# LANDSCAPE ARCHITECTURE DESIGN REPORT - ADDENDUM 01

Centre of Excellence in Agricultural Education

APPLICATION NO. SSD-1500146

*Agriculture Yard Plan Superseded (NTS)*

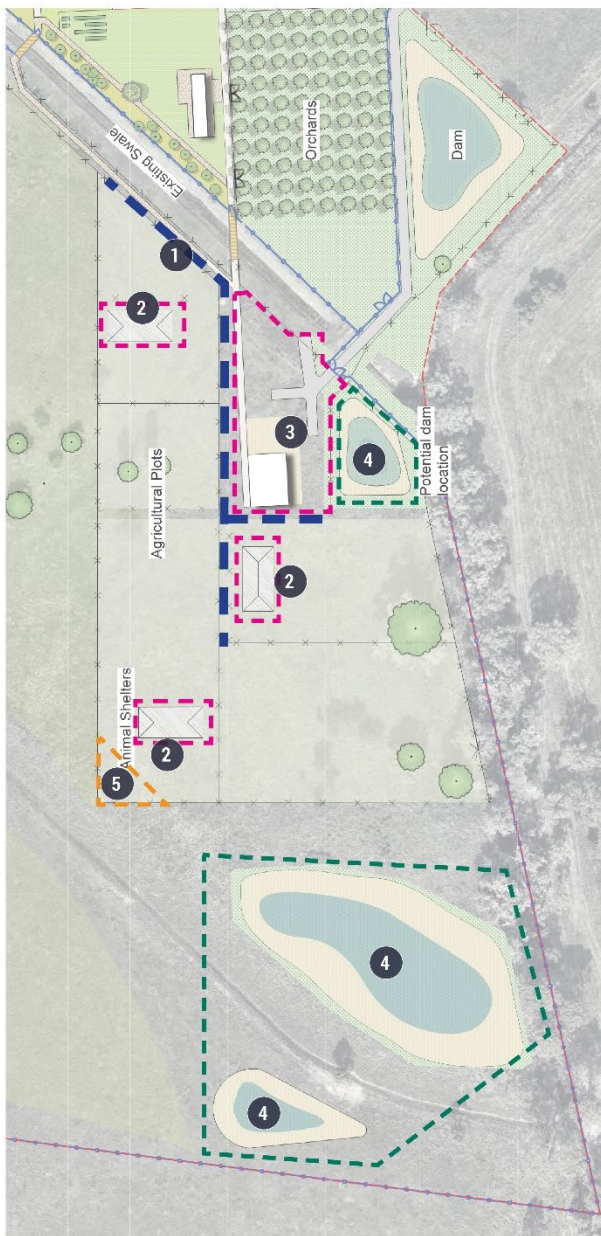
The areas highlighted on the following plans illustrate the extent of change to the agricultural area (refer to page 9 for listed items, to be read in conjunction with the plans). These changes have been the result of several stakeholder meetings to rationalise and make efficiencies in the agricultural layout.

1. Laneway access included to serve agricultural plot layout and livestock movement.
2. Livestock Shelter size rationalised and locations revised.
3. Stock yard
  - Hard paved surface increased to allow for delivery and loading of material, vehicle turnaround and Fire truck access.
  - Rationalised block location to suit access requirement.
  - livestock ramp included.
  - Bulk storage bays included.
4. Consolidated locations of Dams and increased in size.
  - (North of Swale) for Stormwater/Bioretention.
  - (South of Swale) Service the irrigation of site.
5. Revised extent of agricultural plots
